**NOTICE FOR ADDENDUM-IV & CORRIGENDUM-III**

Ref: NIT No.:- SMPK/KDS/CIV/T/2830/12

**Name of Work:** - Development of River Cruise terminal and river tourism facility alongwith riverfront beautification works at KDS, SMP, Kolkata – adjacent to Indenture Memorial area.

COMPILATION OF REPLIES TO PRE-BID QUERIES FOR THE TENDER " Development of River Cruise terminal and river tourism facility alongwith riverfront beautification works at KDS, SMP, Kolkata – adjacent to Indenture Memorial area." Vide NIT No :- SMPK/KDS/CIV/T/2830/12 dated 08/03/2024

**ELECTRICAL MASTER SLD**

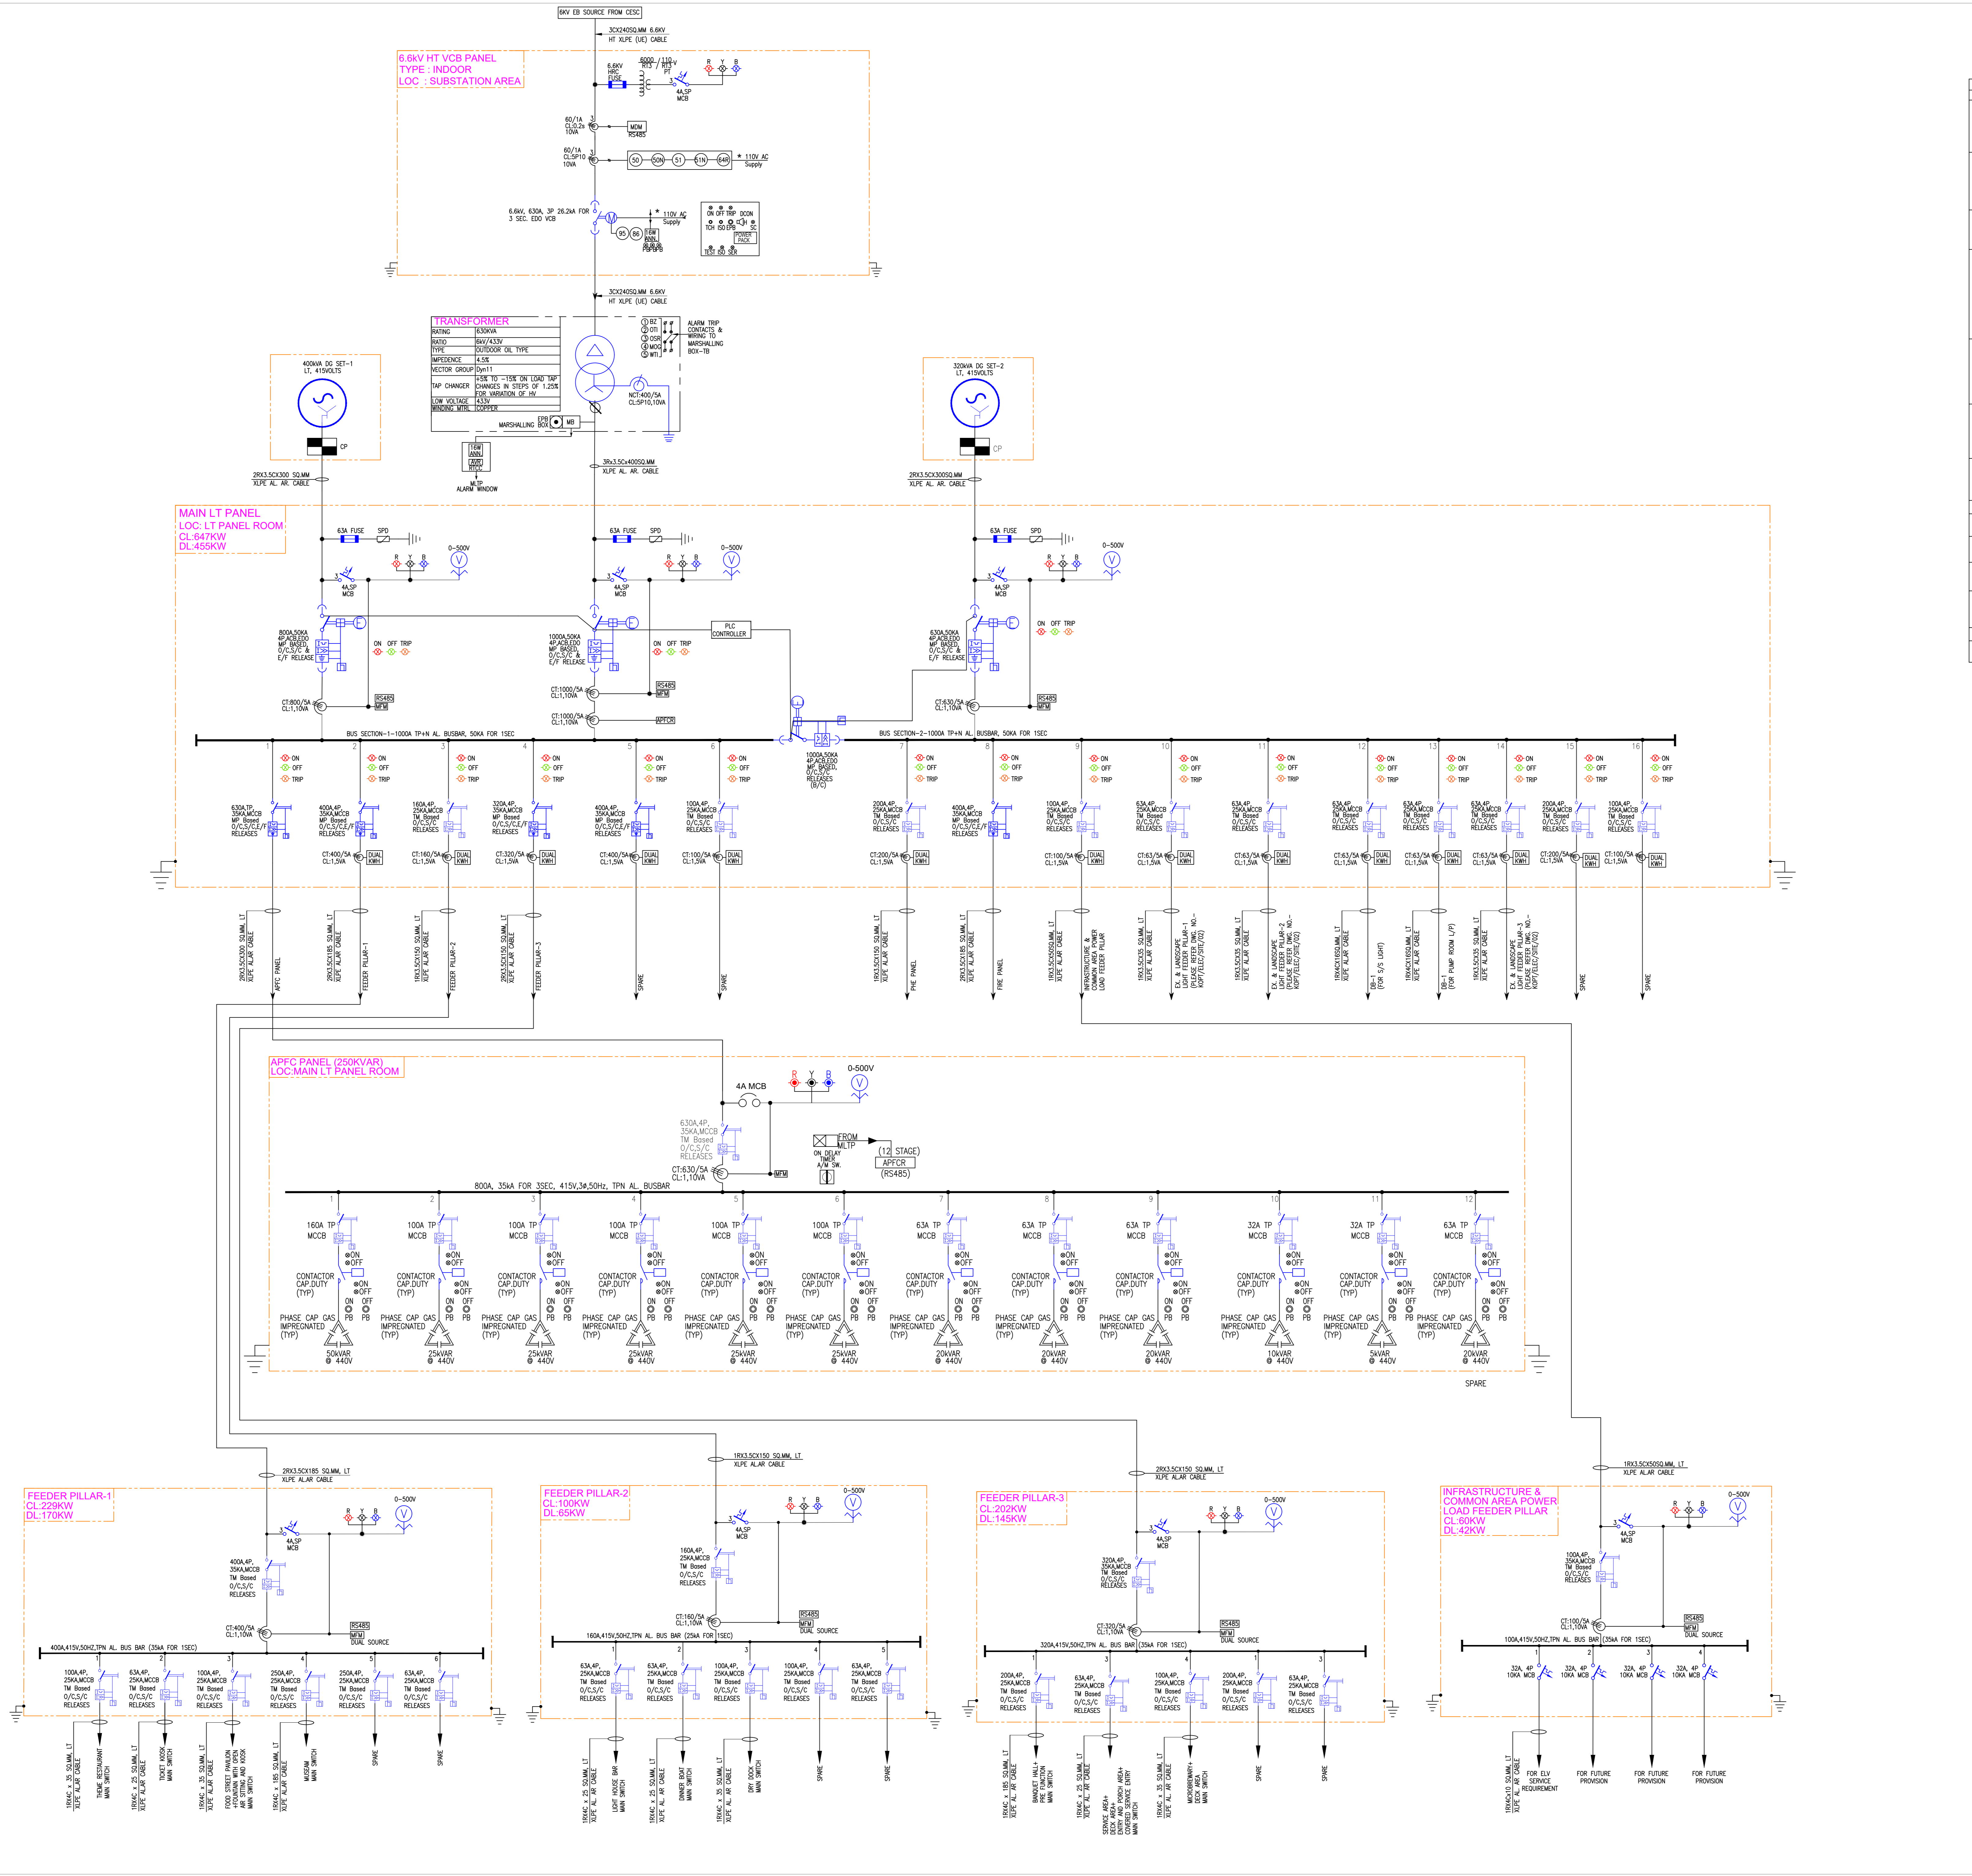
36	14	GI Cable Trays of suitable sizes for all equipment feed supplies.	Quantity & detail specifications required	Rate to be quoted only.
37	15	Commissioning and obtaining the statutory approvals from the concerned including necessary signages . Only technical support	Quantity & detail specifications required	Rate to be quoted only.
<b>ELECTRICAL WORKS</b>				
38	1	11KV/6.6 KV HT 3WAY RMU PANEL (Indoor type)-Optional	Please share the Single Line Diagram	Annexed.
39	2	INDOOR TYPE -6.6kV HT VCB PANEL	Please share the Single Line Diagram	Annexed.
40	8.1	MAIN LT PANEL	Please share the Single Line Diagram	Annexed.
41	8.2	250 KVAR APFC PANEL	Please share the Single Line Diagram	Annexed.
42	8.3	FEEDER PILLAR-1	Please share the Single Line Diagram or make list	Annexed.
43	8.4	FEEDER PILLAR-2	Please share the Single Line Diagram or make list	Annexed.
44	8.5	FEEDER PILLAR-3	Please share the Single Line Diagram or make list	Annexed.

45	8.6	EXTERNAL LIGHTING FEEDER PILLAR-1	Please share the Single Line Diagram or make list	Annexed.
46	8.7	EXTERNAL LIGHTING FEEDER PILLAR-2	Please share the Single Line Diagram or make list	Annexed.
<b>Fire</b>

89	Detailed technical specifications of 6.6 KV/415V Transformer , 11 KV RMU , 11 KV HT VCB panel and APFC Panel alongwith SLD are required .	SLD Annexed. Please refer technical specifications and tender drawings for further details.
----	-------------------------------------------------------------------------------------------------------------------------------------------	---------------------------------------------------------------------------------------------
